Re: State Specifications Office

Section: 120

Proposed Specification: 1200101 Excavation and Embankment

EXCAVATION AND EMBANKMENT (REV 9-25-24)

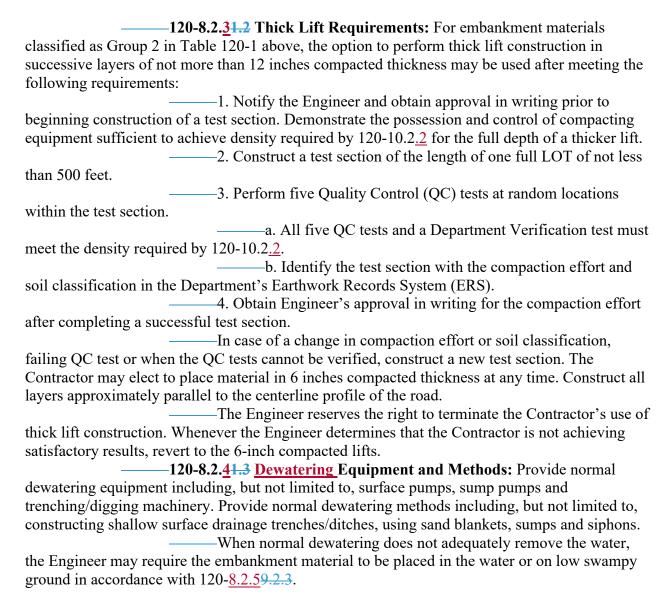
——120-8.2.21.1 Maximum Compacted Lift Thickness Requirements: Construct the embankment in successive layers with lifts up to a maximum listed in Table 120-1 below based on the embankment material classification group.
